**DOCUMENT 00 90 00**  
**ADDENDUM**

**ADDENDUM No.:** 2

**RE:** HOUSING AUTHORITY OF THE CITY OF LA CROSSE  
2024 SMOKE ALARMS  
LA CROSSE, WISCONSIN 54601  
PROJECT NO. 24034

E801

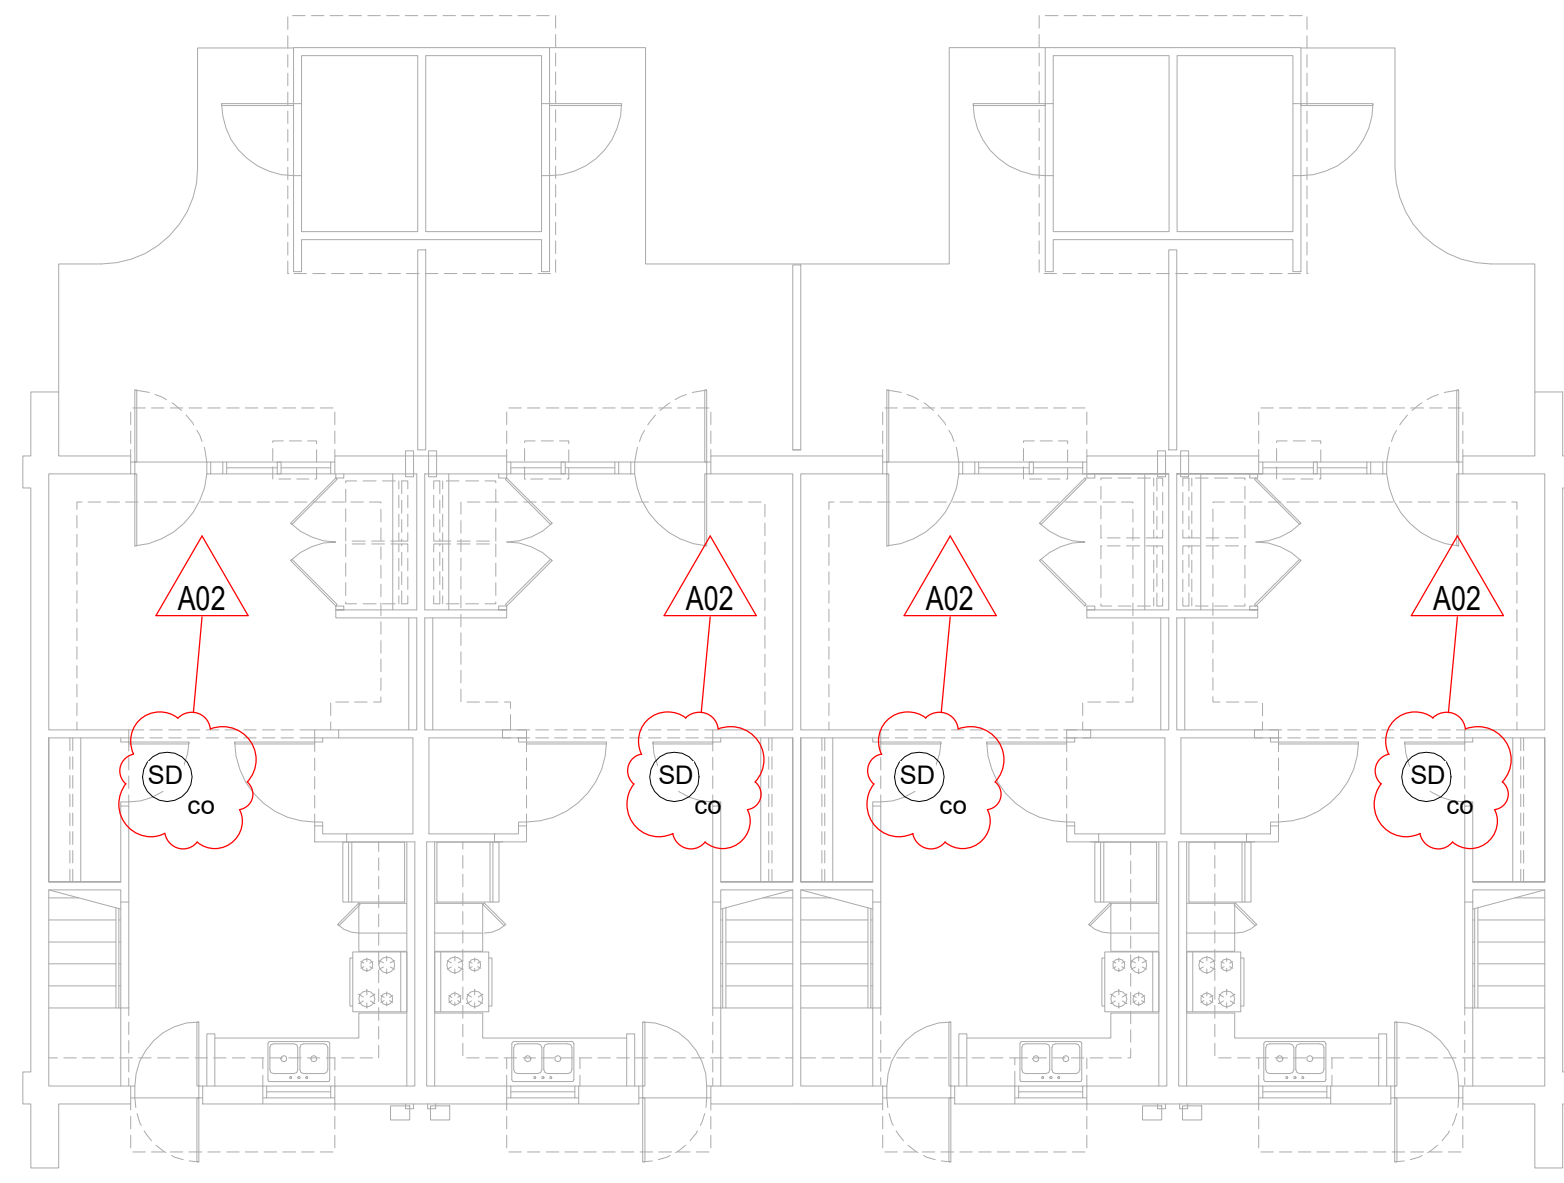
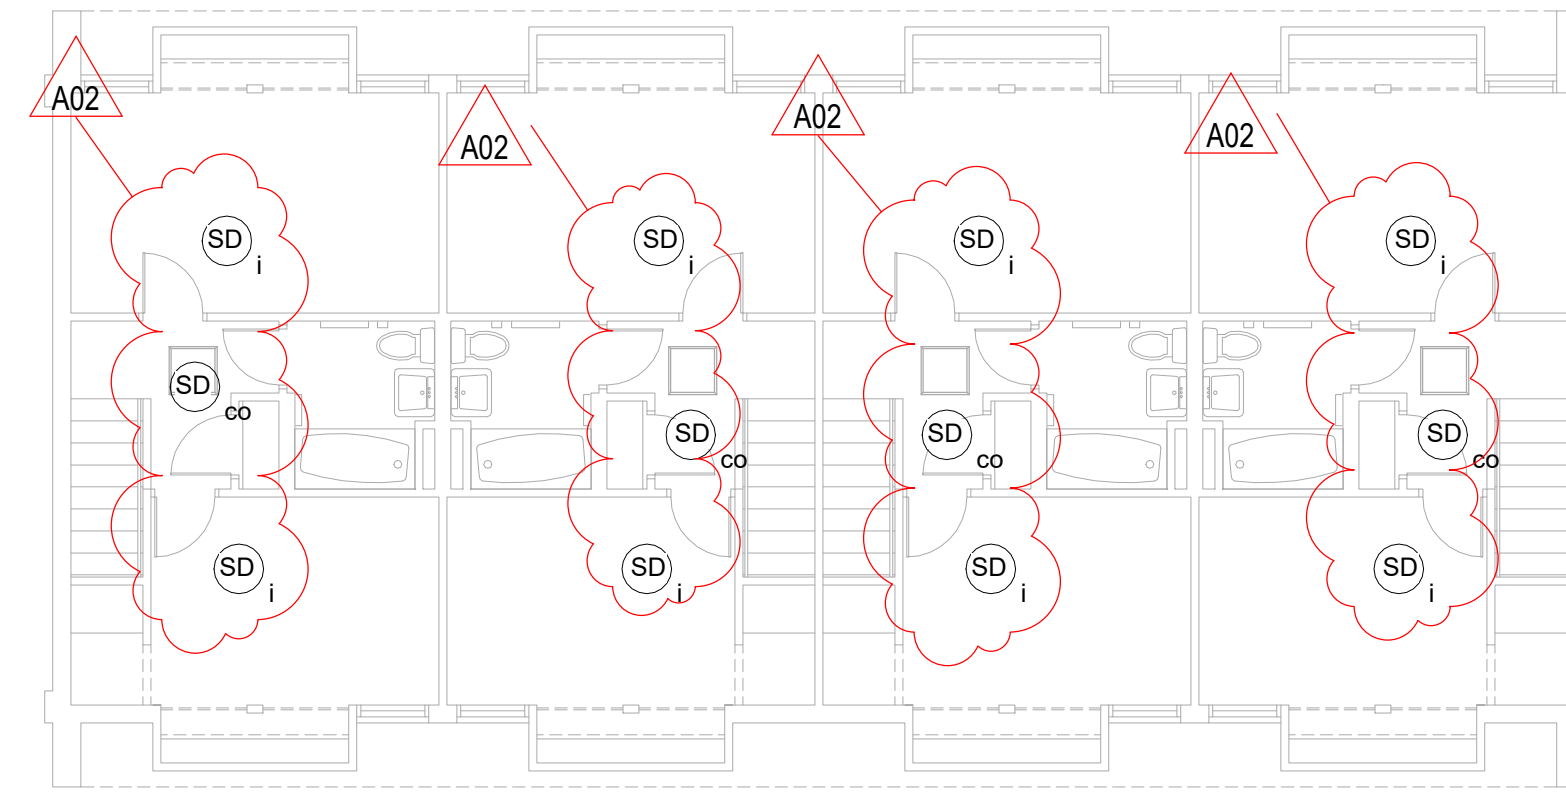
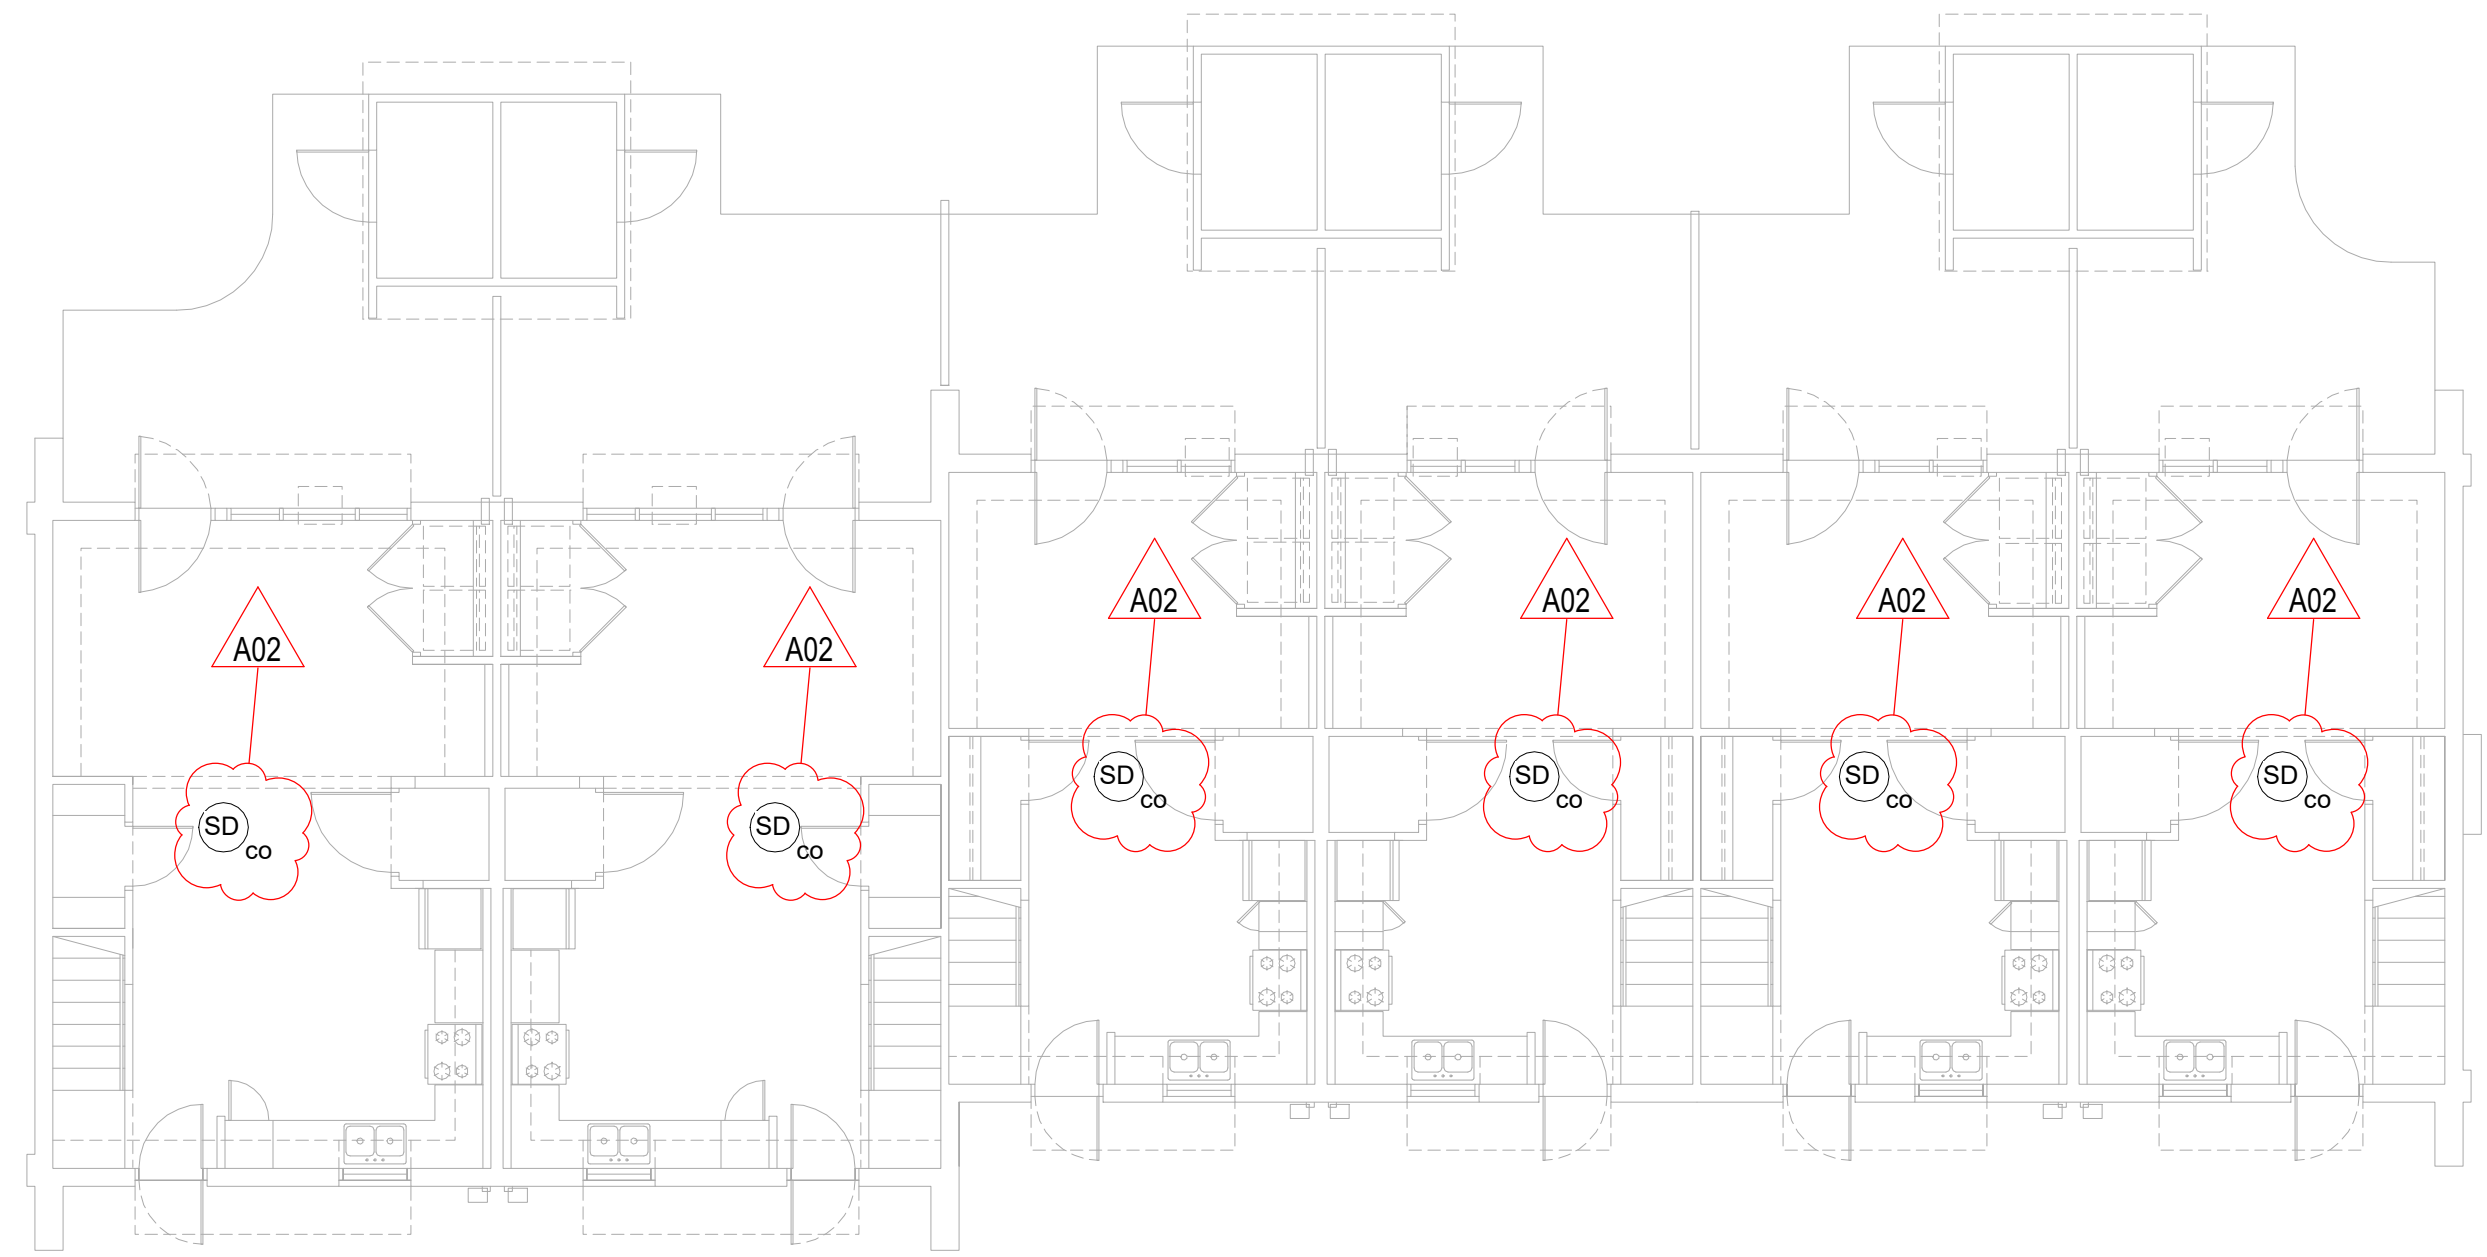
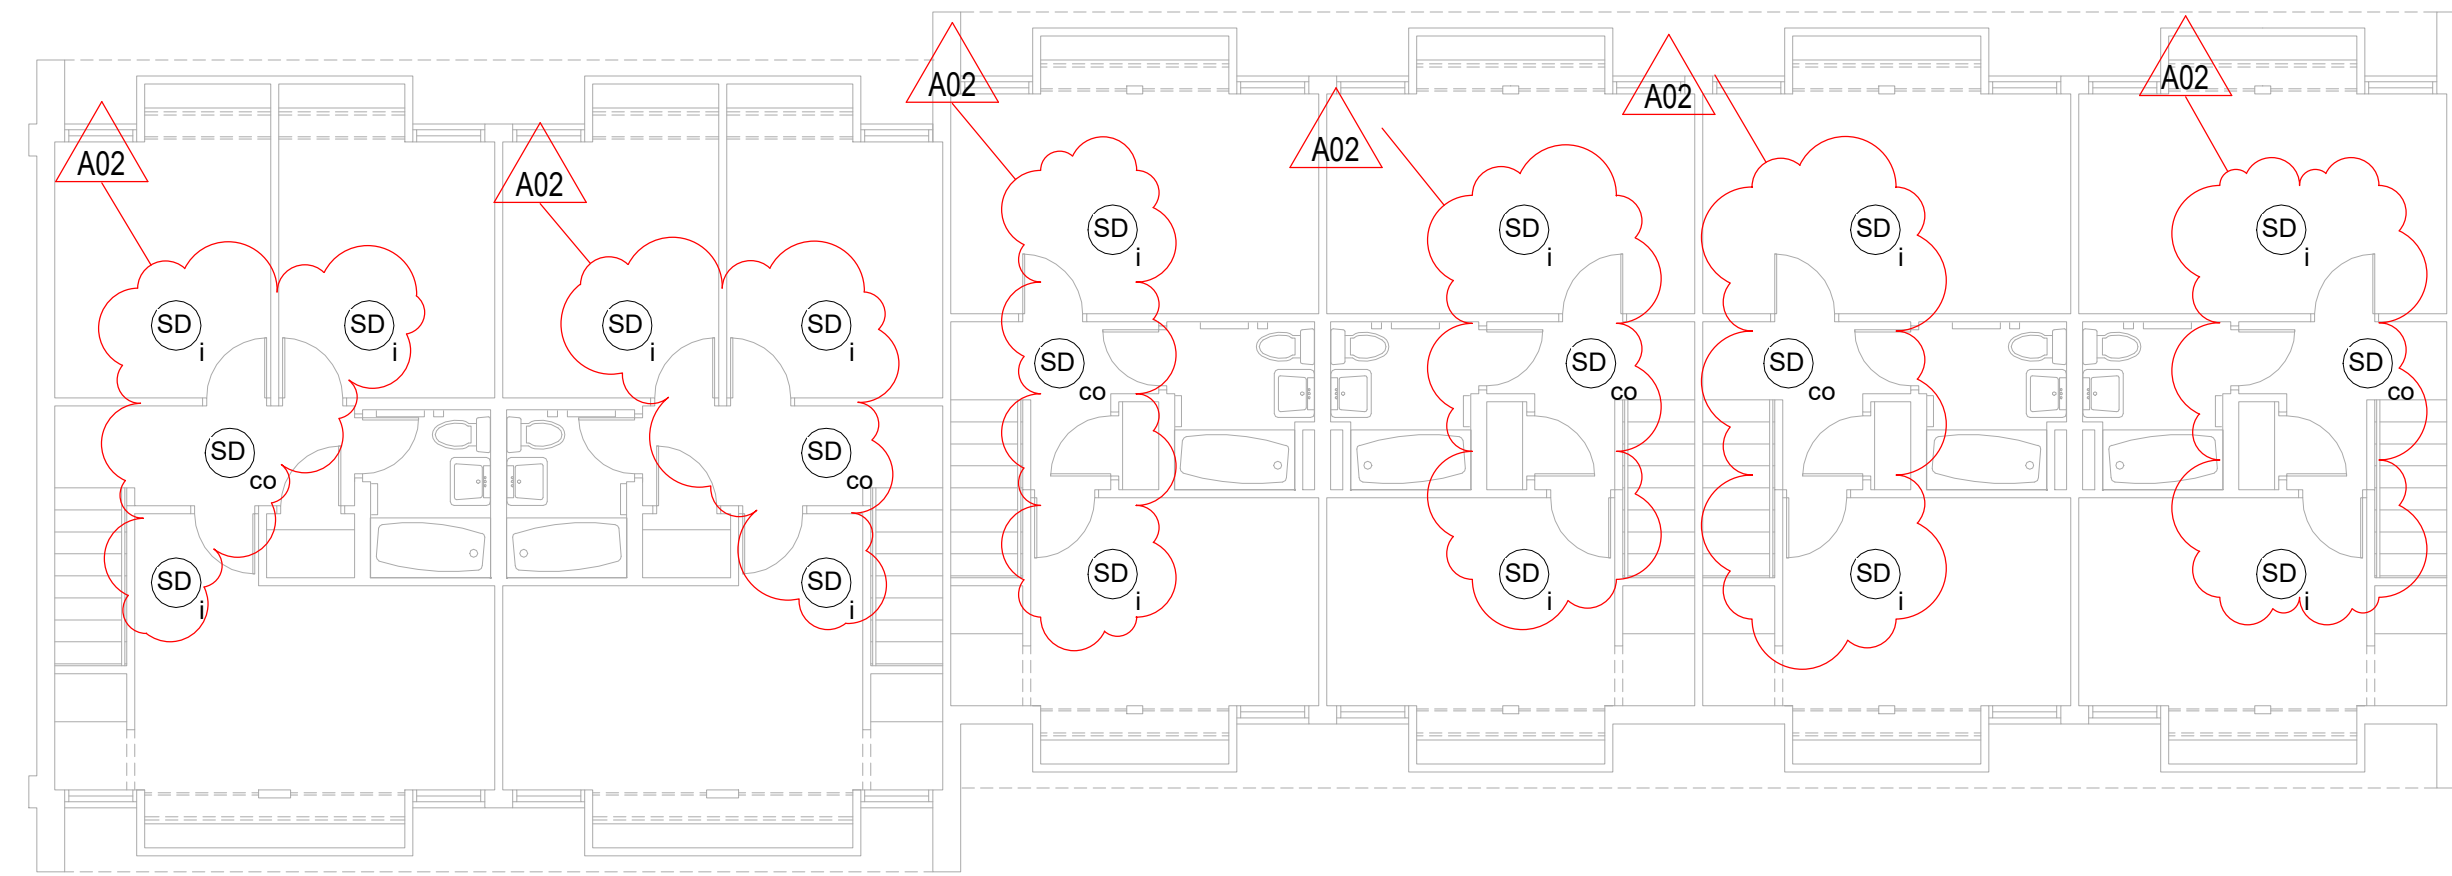
15. Sheet E801 SMOKE ALARM UNIT PLANS 30"x42"

- a. See the revised sheet included in this addendum. Disregard the previous version.
- b. Revised sheet to reflect a changed approach from wired smoke alarms to wireless. See clouded changes for requirements.
- c. Added notes regarding removal of existing equipment.
- d. Revised clouded plan views to remove wiring and conduit.
